Agnico Eagle Mines Limited – Meadowbank Division

**Whale Tail Pit Management Plans
AEM RESPONSES TO ECCC & CIRNAC Reply
Waste Rock Management Plan, Water Management
Plan, Water Quality and Flow Monitoring Plan**

November 23 2018

ARD/ML Plan Attachment B: Flow Chart

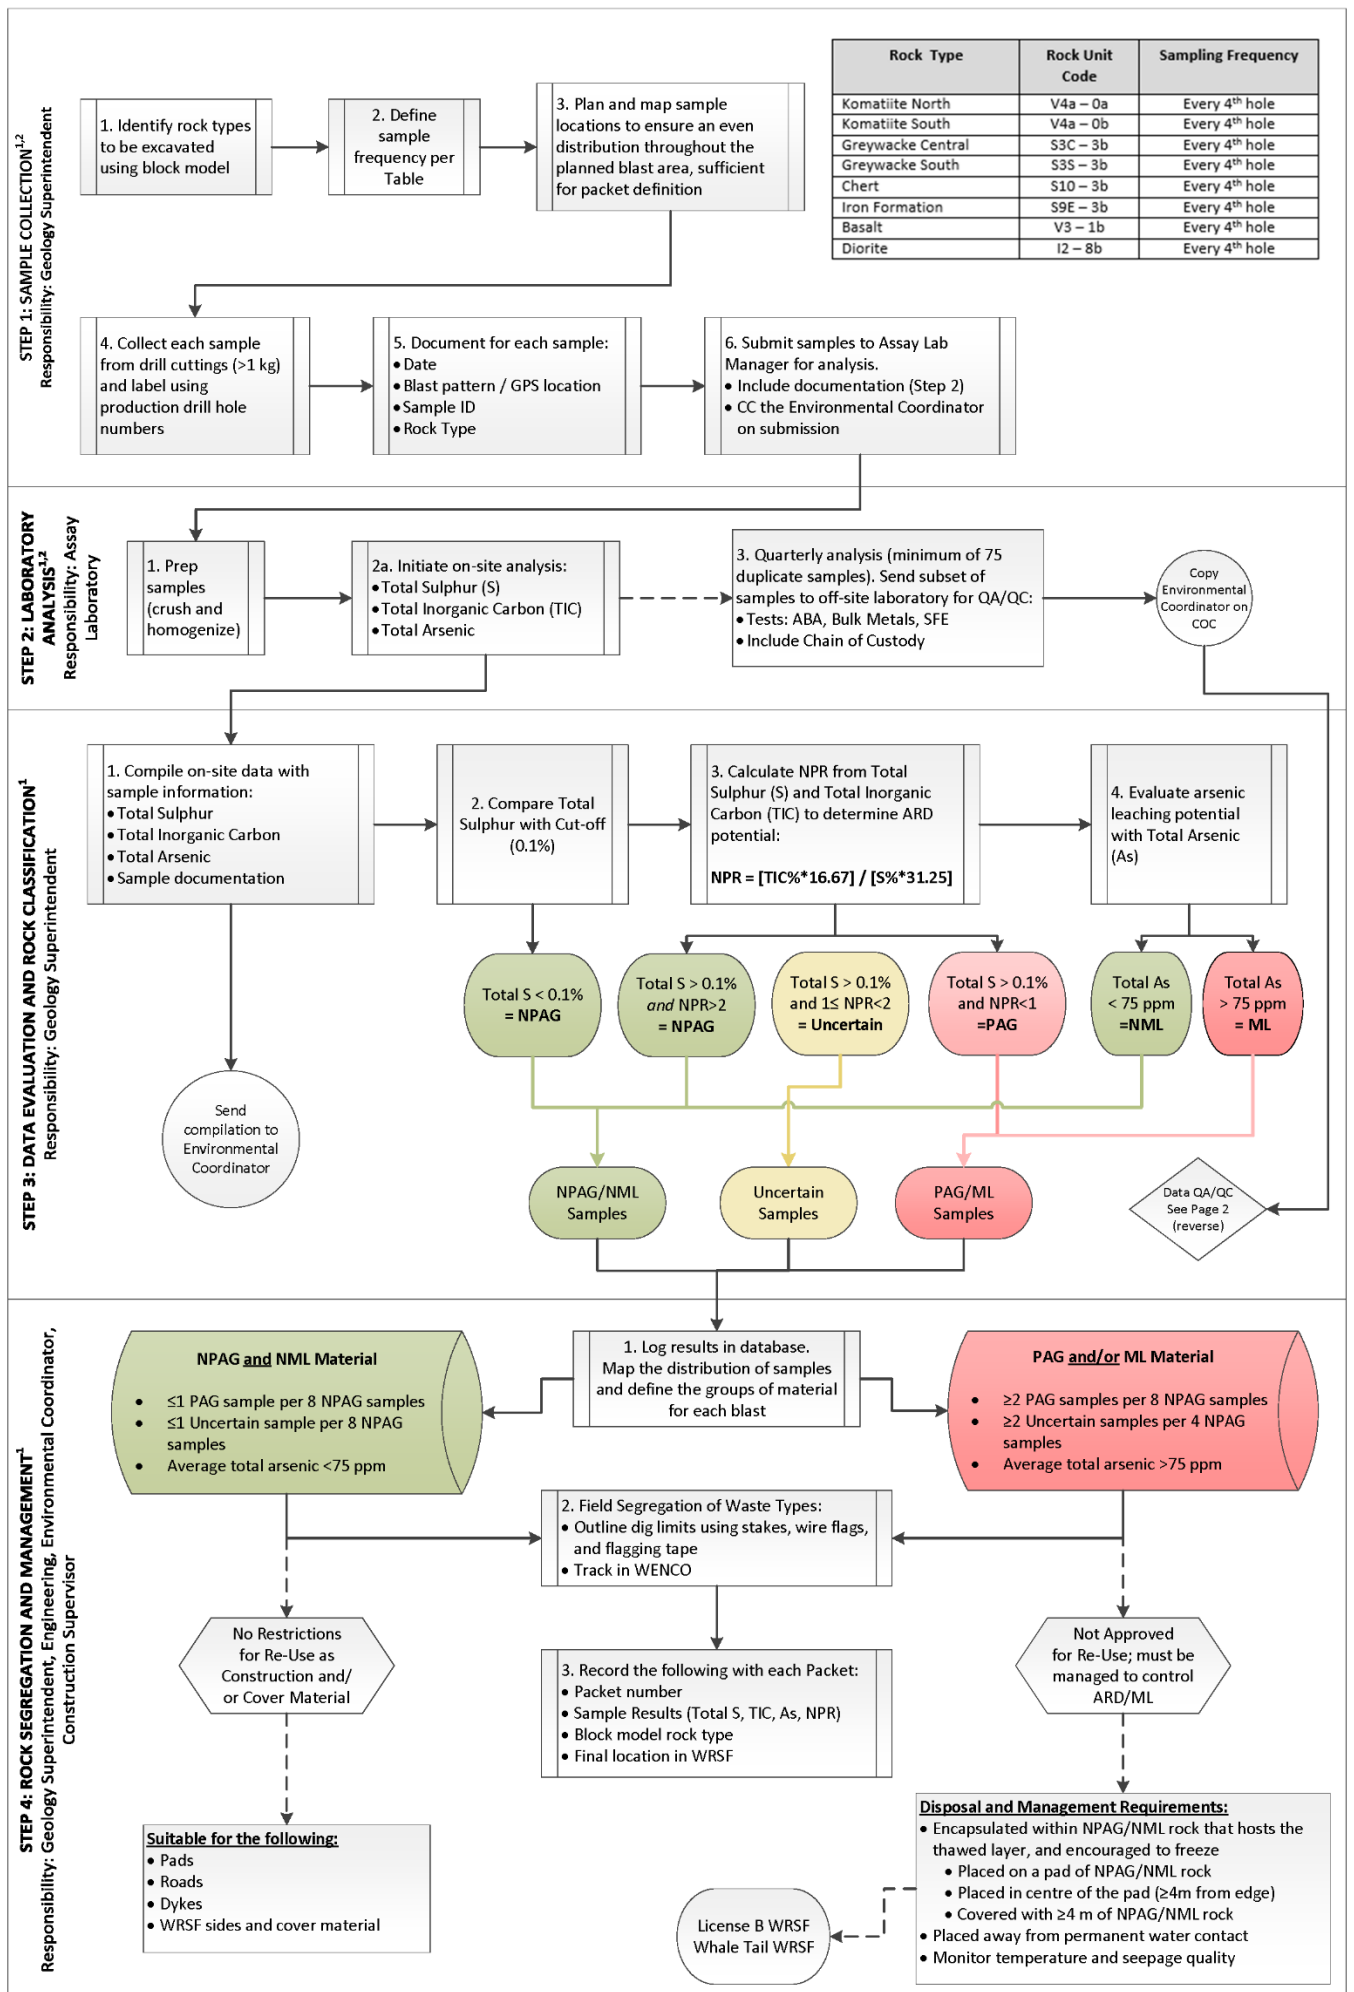
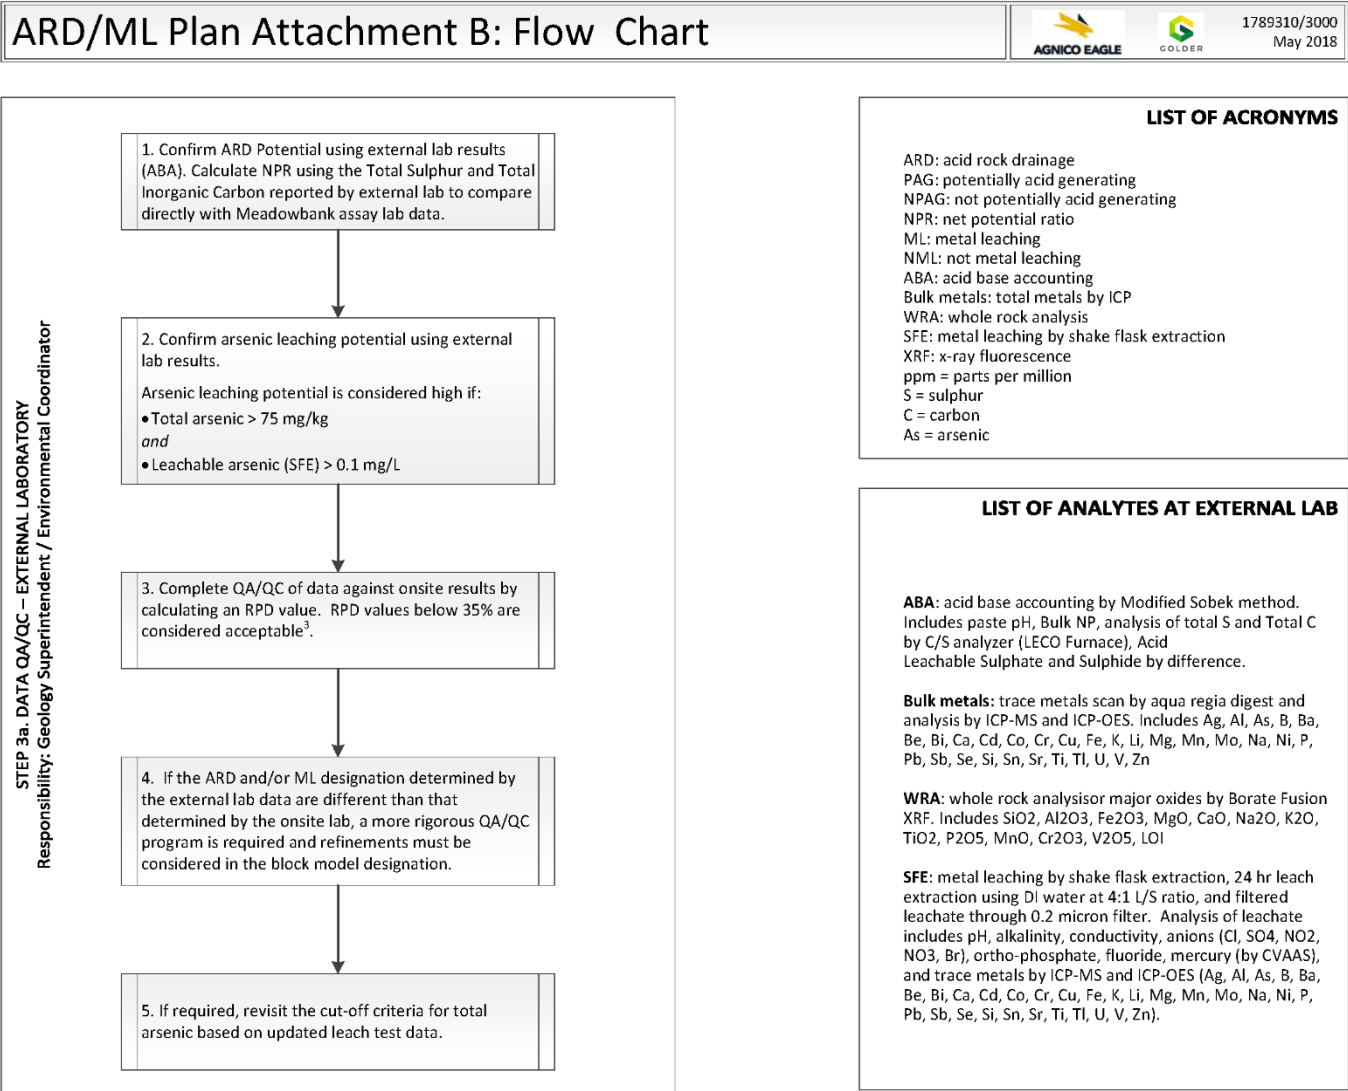
CIRNAC and AEM agree that based on AEM’s model predictions, the waste rock storage facility (WRSF) cover needs to be at least 4.7 meter thick and be constructed with 100% “clean” waste rocks (i.e. Non Potential Acid Generation (NPAG) and Non Metal Leaching (NML) waste rocks) or be contaminant-free (i.e. free of any Potential Acid Generation (PAG) waste rocks and free of any Metal Leaching (ML) waste rocks). The Whale Tail Waste Rock Management Plan needs to be developed such that, if implemented, no PAG waste rocks or ML waste rocks would be misidentified and misplaced in the cover.

AEM has set a high standard for “clean” waste rock for the Whale Tail project WRSF cover. However, AEM continues to submit the Meadowbank Waste Rock Segregation plan which CIRNAC has made clear is not site specific to the Whale Tail Pit project geology and geochemical concerns. AEM acknowledges that waste rocks from the Whale Tail pit have much higher metal leaching potentials than those from the Meadowbank pits. CIRNAC asserts that the Meadowbank Waste Rock Segregation Plan does not provide enough detail or assurances that AEM can achieve its goal with the plan (e.g. the plan does not prescribe how ML waste rocks would be segregated from NML waste rocks).

CIRNAC is requesting a site specific Waste Rock Segregation plan with additional detail on AEM’s methodology and practices to achieve the goal of constructing a contaminant-free WRSF cover.

As discussed previously, we feel the best format is to have this segregation plan in one location as it will be easier to update if required. For your reference, please find below the excerpt from initial Agnico Eagle response to CIRNAC:

Agnico Eagle [...] refers CIRNAC to the ARD-ML Sampling and Testing Plan Appendix B “Flow Chart for Waste Rock delineation and segregation” shown below. Step 4: Rock segregation and management gives implementable details on how the two (2) different types of waste (i.e. NPAG and NML and PAG and/or ML) will be disposed of during Operations. Agnico Eagle would like to clarify that waste rock segregation is not based only on rock type or lithology but rather on operational ARD-ML testing results. [...]

Agnico Eagle requests the NWB to make a final decision on this as this question has already been responded to CIRNAC multiple times.

Figure 1: Thermistor AMQ17-1265A readings

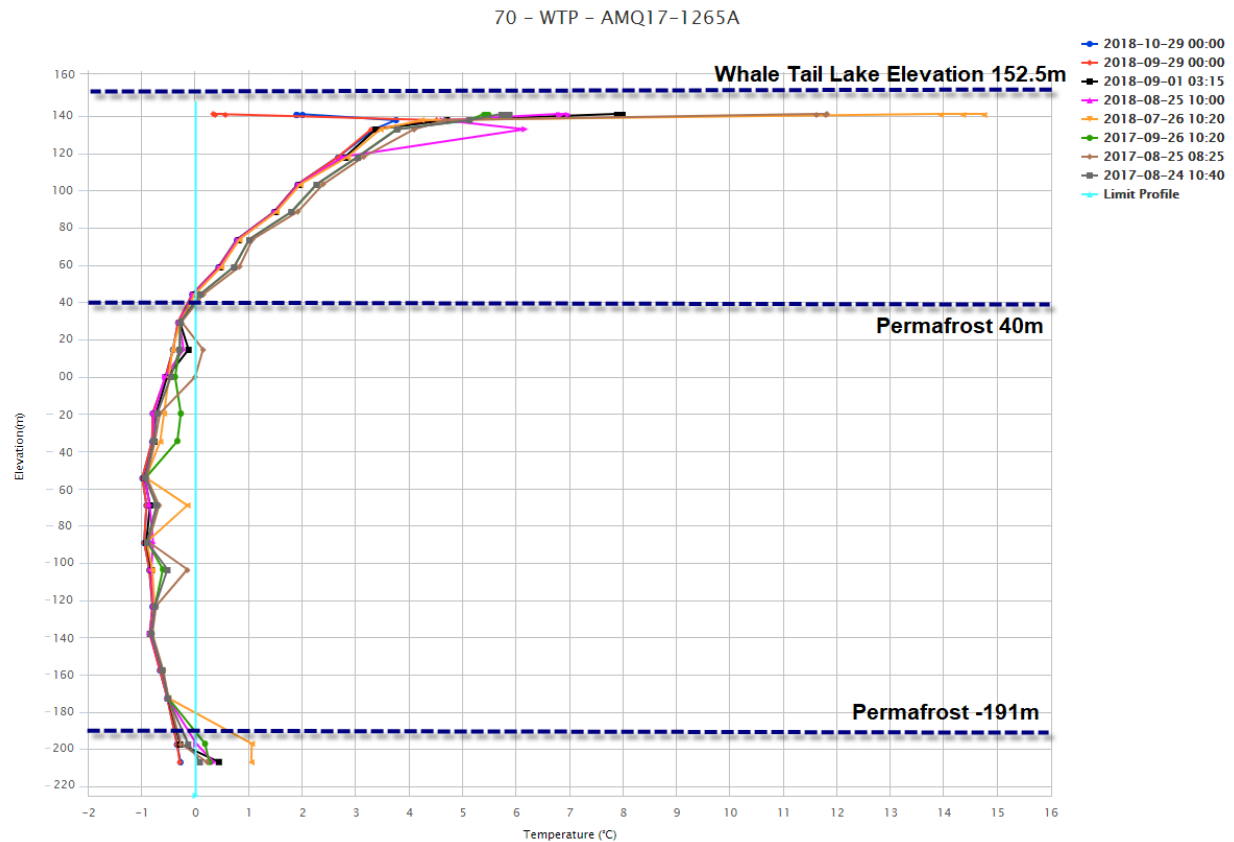
AEM used regional sub-permafrost groundwater flow system calculations, based on regional lake water levels, to determine the site specific Whale Tail Pit project hydrogeological characterization. Based on the site specific concerns for long-term arsenic leaching at the Whale Tail Pit project, CIRNAC views the regional approach alone without Whale Tail site specific field data to substantiate the hydrogeological modeling and validate the underlying hydrogeological assumptions to be lacking. In the absence of the site specific data, CIRNAC would request AEM provide data to validate the talik below Whale Tail Lake is open to the sub-permafrost groundwater flow system.

The width and shape of lakes in the Hydrogeology Baseline Study Assessment were reviewed as part of the Approved Project to estimate if open taliks could be present below the lakes. Based on analytical solutions presented in Burn (2002), Golder estimated that open taliks could be present for circular lakes with a radius of greater than about 300 m and for elongated lakes with a half-width of greater than about 150 m, which includes Whale Tail Lake.

For the Whale Tail Lake area, thermal data is presently available from 10 thermistors (Knight Piésold 2015; Golder 2017, 2018). Data from thermistor AMQ17-1265A indicates that the talik near the central portion of the North Basin of Whale Tail lake extends about 112 m below the lake water level of 152.5 masl. Figure 1 and 2 are presenting readings of the thermistor AMQ17-1265A and the location of the thermistors installed at the Whale Tail site. Toward the South Basin, the closed talik below the North Basin is predicted by thermal modelling to transition to an open talik with direct connection to the sub-permafrost groundwater flow system.

Although direct thermistor measurements are not available for the inferred open talik area in the South Basin of Whale Tail Lake, analytical models for circular and elongated lakes and 2-D numerical thermal analysis predict an open talik would be present. The assumption of an open talik below the South Basin is conservative with respect to the prediction of potential groundwater inflow to the dewatered open pit, as it allows for higher inflows and the potential inflow of deeper saline groundwater into the open pit. If an open talik is not present, groundwater inflows could be less than predicted and of lower TDS.
